## Reply to the comments of referee #1

The title has been changed to “Experiences and Lessons Learned from Designing and Testing of an Air System and a Drilling Fluid Circulation System Adapted for Subglacial Bedrock Drilling in Antarctica”. In the new title, the “experiences and lessons” is emphasized, and the two systems are emphasized to be used for subglacial bedrock drilling in Antarctica.

**Figure S1. Flow rate and pressure of drilling liquid required in ice drilling (a) and subglacial bedrock drilling (b)**

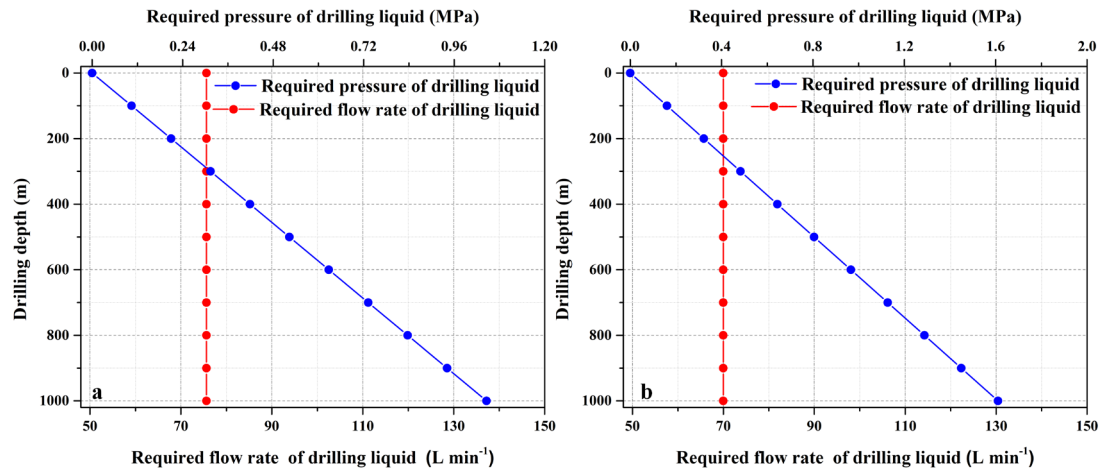
**L257-258. Refereeing to Alemany et al. (2021) in order to choose flow rate and pressure required for ice and subglacial bedrock drilling is incorrect method because borehole depth, diameters of**

drill pipes and bits are absolutely different. Authors should provide their own estimation of surface pump requirements.

L261. Why 2 MPa. Reference?

We only use the method provided by Alemany et al. 2021, instead of choosing the flow rate and pressure according to their results. Our estimation is based on the type of drilling liquid, borehole depth, borehole diameter, and drill-rod size. The details of the estimation are as following.

*The flow rate and pressure of drilling liquid required in ice drilling and subglacial bedrock drilling can be calculated according to Alemany and others (2021). In the calculation, the penetration rate is also set as 100 m/h, while the concentration of ice chips is assumed to be 0.025. Kerosene JET-A1 is assumed to be drilling liquid. The drilling fluid are considered to be at the temperature of  $-30^{\circ}\text{C}$ , which has a density of  $846\text{ kg/m}^3$  and a viscosity of  $5.29\times 10^{-6}\text{ m}^2/\text{s}$  (Talalay and Gundestrup, 2002). The safe factor of pressure is set as 1.5. In both ice drilling and subglacial bedrock drilling, the maximum drilling depth is considered to be 1000 m. It is worth to be mentioned that liquid reverse circulation is used in ice drilling while liquid normal drilling is used in subglacial bedrock drilling.*

*As shown in the following Fig. S1, the required flow rate keeps constant with increased drilling depth. In our case, the flow rate is about 76 L/min. However, the required liquid pressure during ice drilling increasing linearly with drilling depth increasing. In a 1000 m borehole, the required liquid pressure can be more than 1.0 MPa. The required flow rate and pressure in subglacial bedrock drilling has the same variation trends as in ice drilling. To obtain bedrock sample below 1000 m ice, the required flow rate is less than 70 L/min and the required pressure is about 1.6 MPa. To ensure the ability of the drilling-fluid pump, it is expected to have a rated flow rate of 100 L/min and maximum pressure of the 2 MPa.*

As mentioned above, the estimation of the flow rate and pressure needs the type of drilling liquid, borehole depth, borehole diameter, and drill-rod size. The detailed information will be provided in our coming paper about the whole MPDS, including the calculation process of flow rate and pressure. In the study, we focus on the design and test results of the drilling liquid circulation system, so the estimation is not contained in the manuscript.
